**Appendix B**  
**Agency Coordination**

**Re: Request for Project Review – Goldthwaite Brook Flood Mitigation Project, Essex County, Massachusetts**

**RE: Project Review: Goldthwaite Brook Flood Mitigation Project, Essex County, MA**

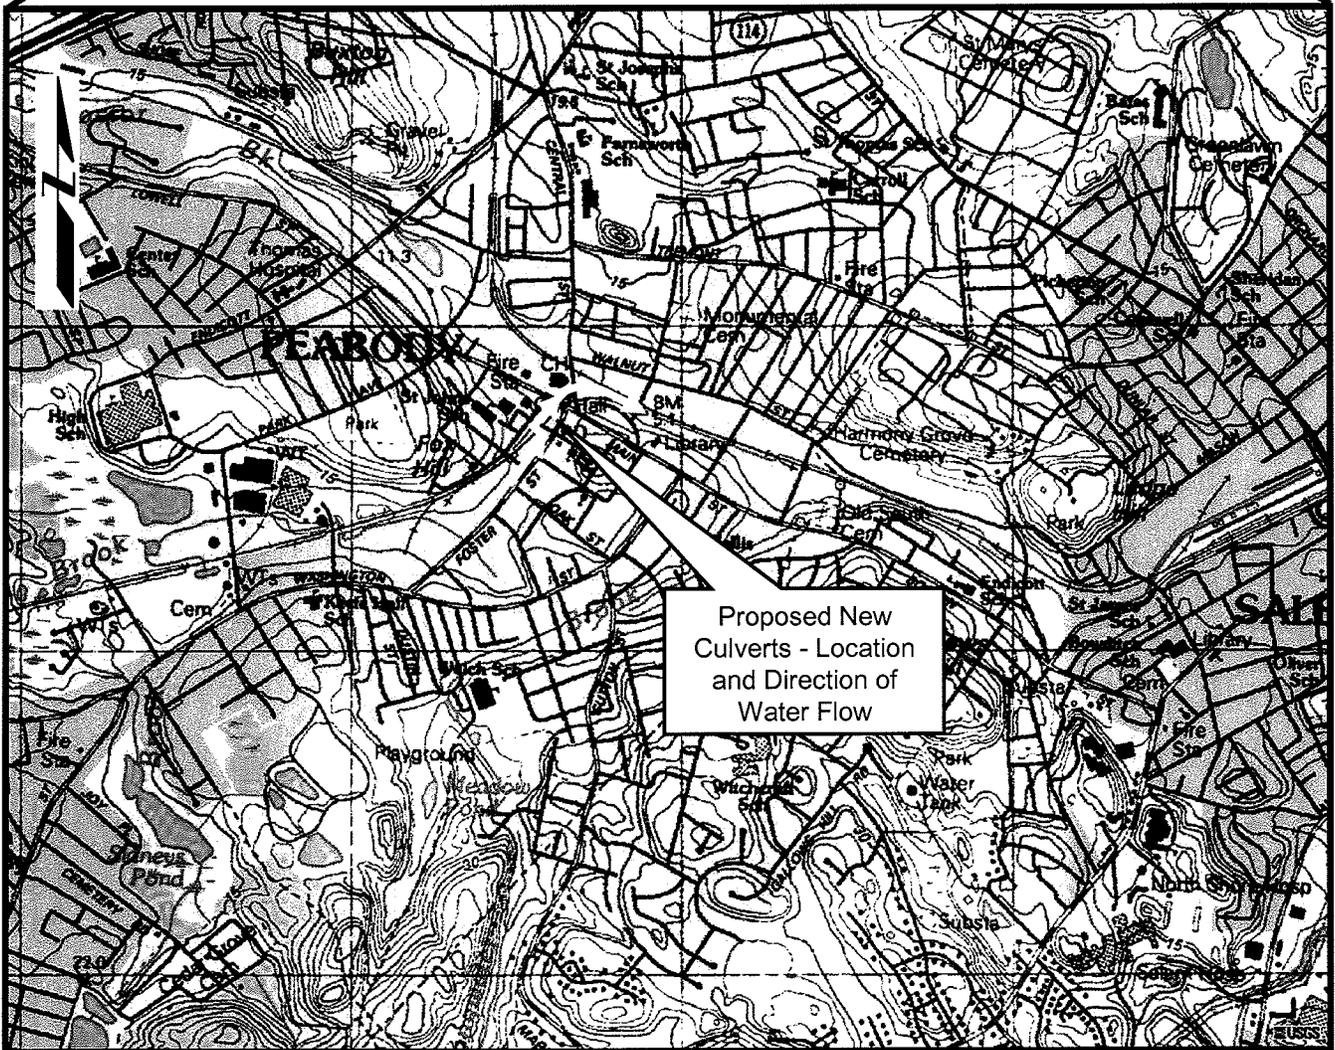
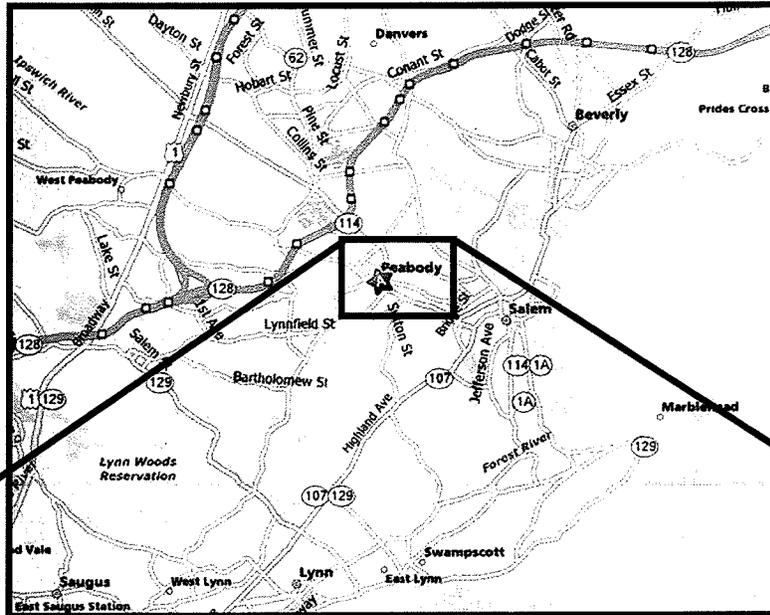
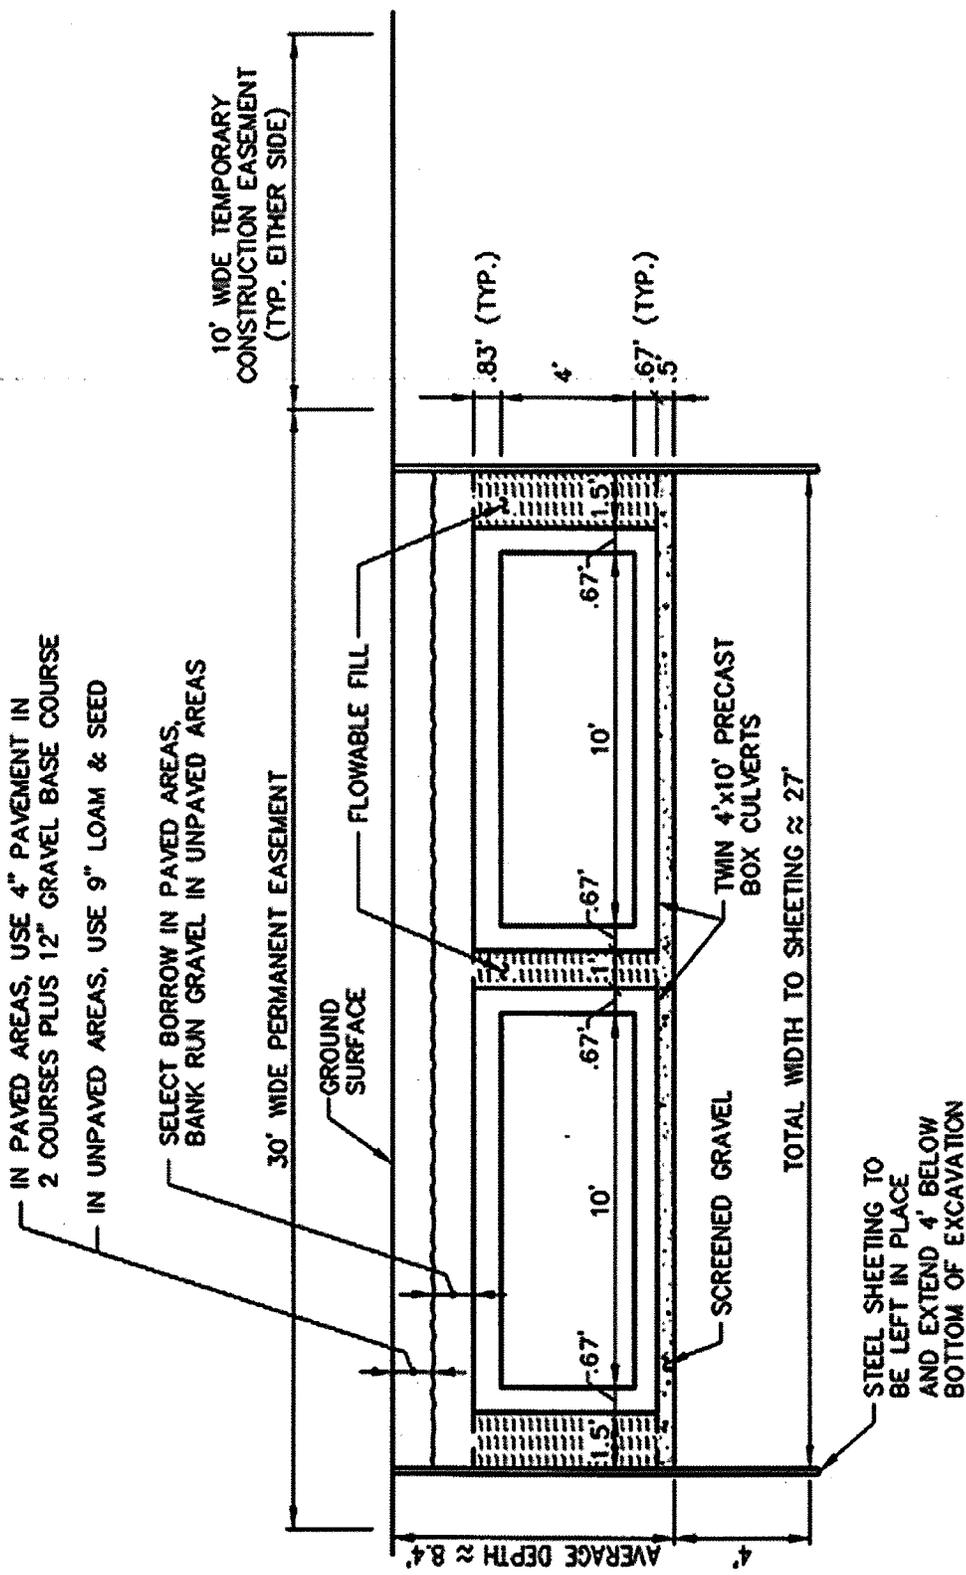
MassHighway has reviewed the enclosed figures 1-3 that were provided with your letter as well as the Flood Mitigation Plan prepared by Metcalf & Eddy on behalf of the City of Peabody, and have the following comments:

Within the Draft PDR, M&E/AECOM present flood discharges and water surface profiles for the North River at Howley Street that are greater/higher than those presented in the Peabody FIS. For example, Figure 3-19 of the PDR shows a North River existing condition 50-year discharge peak of 1026 cubic feet per second (cfs) at Howley Street. The Peabody FIS lists a 990 cfs discharge peak for the North River at the same location. Further, Table 3-13 of the PDR lists a North River existing condition 50-year flood elevation of 12.85 feet (no datum provided) at Howley Street. Flood Profile Sheet 02P of the Peabody FIS shows a 50-year flood elevation of 11.8 feet, NGVD at the same location.

These discrepancies are a concern to MassHighway because peak 10-, 50-, 100- and 500-year flood discharge and water surface profile data from the Peabody FIS were used to design the waterway opening for a new single span bridge proposed as a replacement for the existing Howley Street bridge. Accordingly, MassHighway has requested that M&E/AECOM inform the Department whether or not the hydrologic and hydraulic analysis performed during the preparation of the Draft PDR will be used to revise the Peabody FIS in the future.

If the PDR analysis will be used to revise the City's FIS, then MassHighway further requests that M&E/AECOM forward a tabulation of the peak 2-, 10-, 50-, 100- and 500-year flood discharges and river stages they calculated for the North River at Howley Street under existing and proposed (all three flood mitigation projects implemented) conditions.

MassHighway requests that M&E/AECOM identify the vertical datum of the elevation data presented in the Draft PDR.

MassHighway requests that M&E/AECOM confirm that no significant changes to the North River's existing flooding regime are expected to occur at Howley Street in the event Projects 1 and 2 (North River Widening from Wallis Street to Howley Street) are implemented, but Project 3 (North River Widening from Howley Street into the City of Salem) is not.

CLIENT FEMA				TITLE AERIAL PHOTOGRAPH	
PROJ Goldthwaite Brook Flood Mitigation Project					
REVISION NO	DES BY				PROJ NO 15707048
SCALE	NTS	DR BY	ECV	9/11/08	FIGURE 2
FILE		CHK BY	X	X

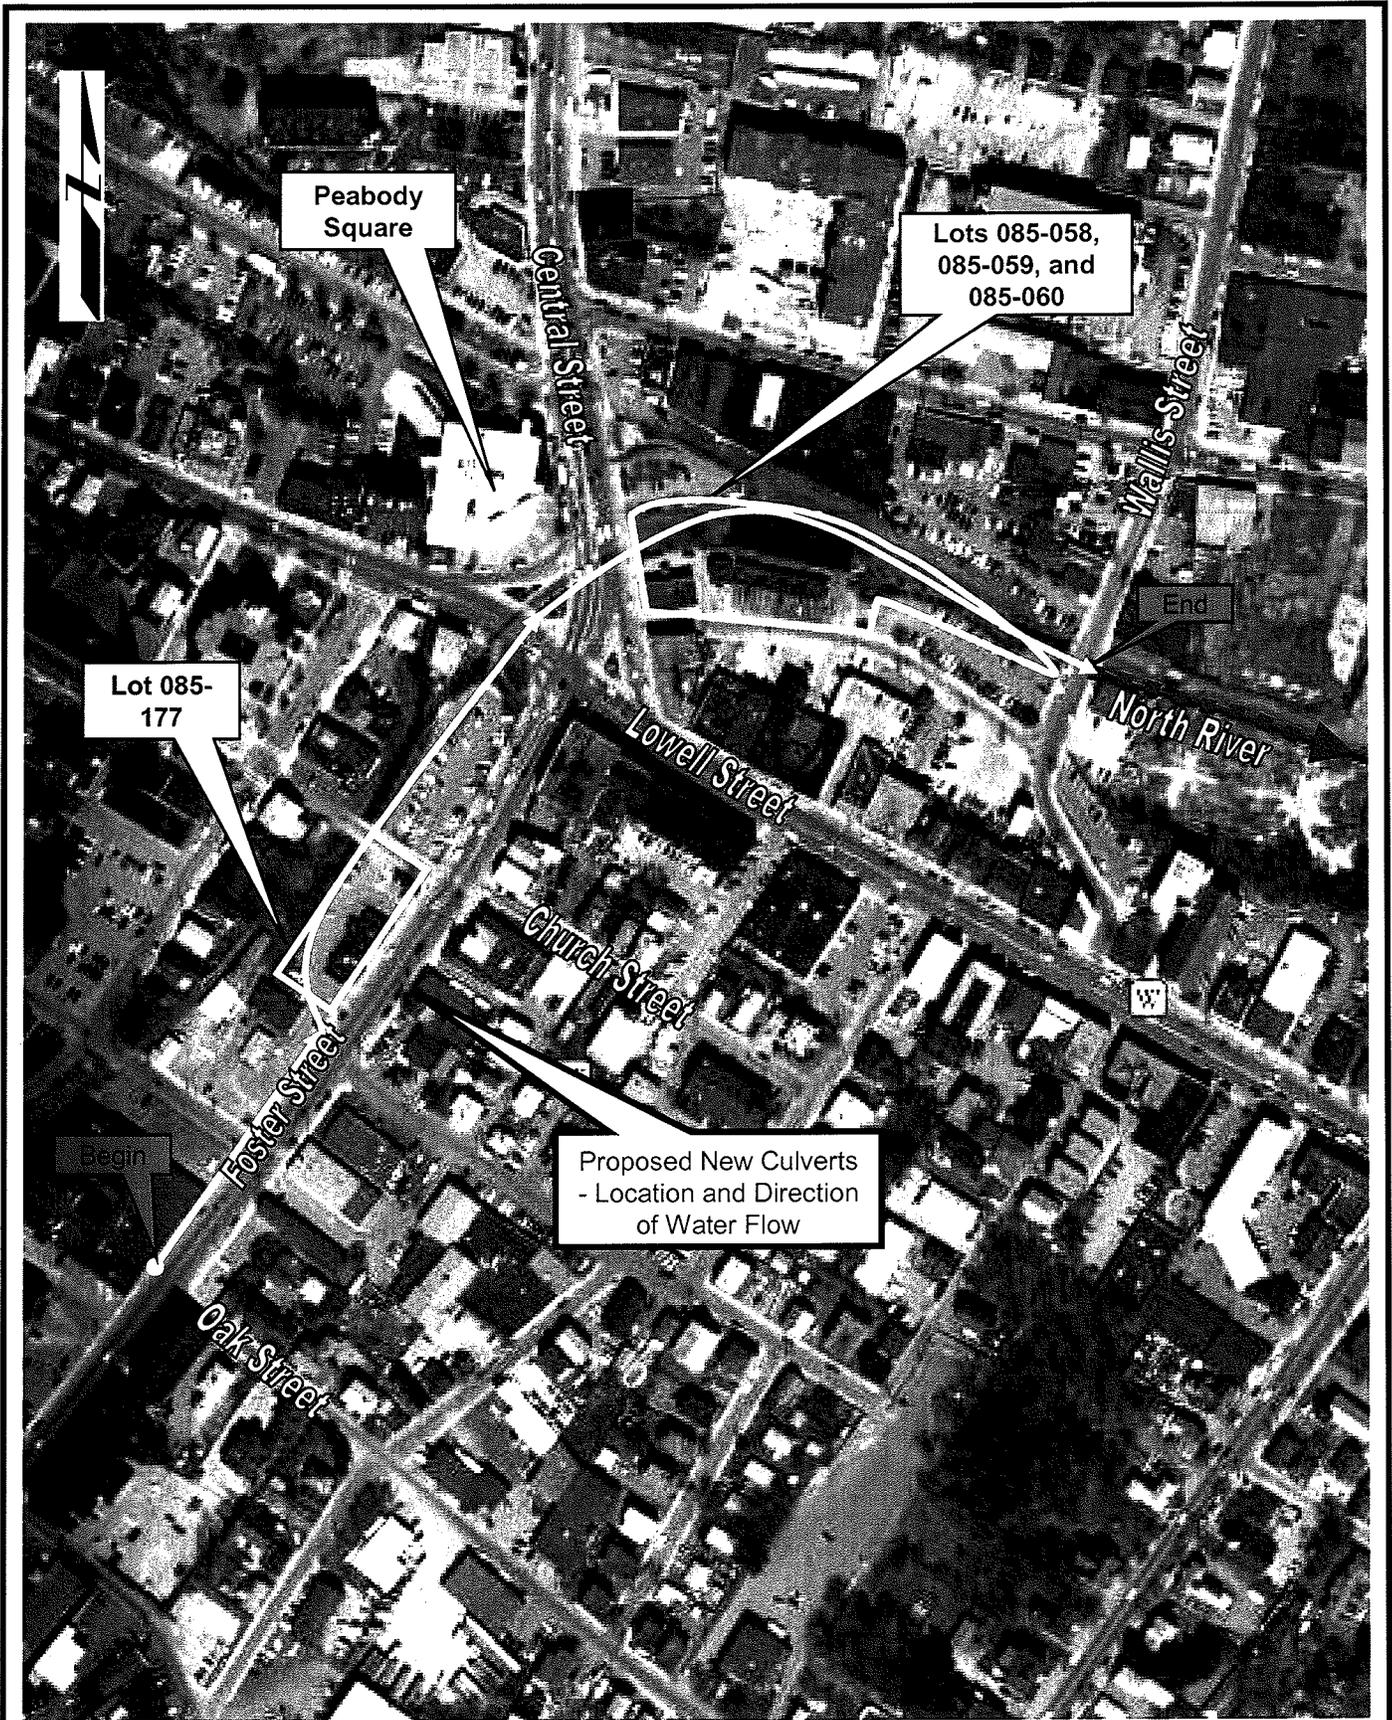
In reference to your letter dated September 18, 2008, we do not have any information for the study area shown in Fig 2 (Phase 1). Our primary focus is Phase 3, and all our data collection efforts pertain to that phase.
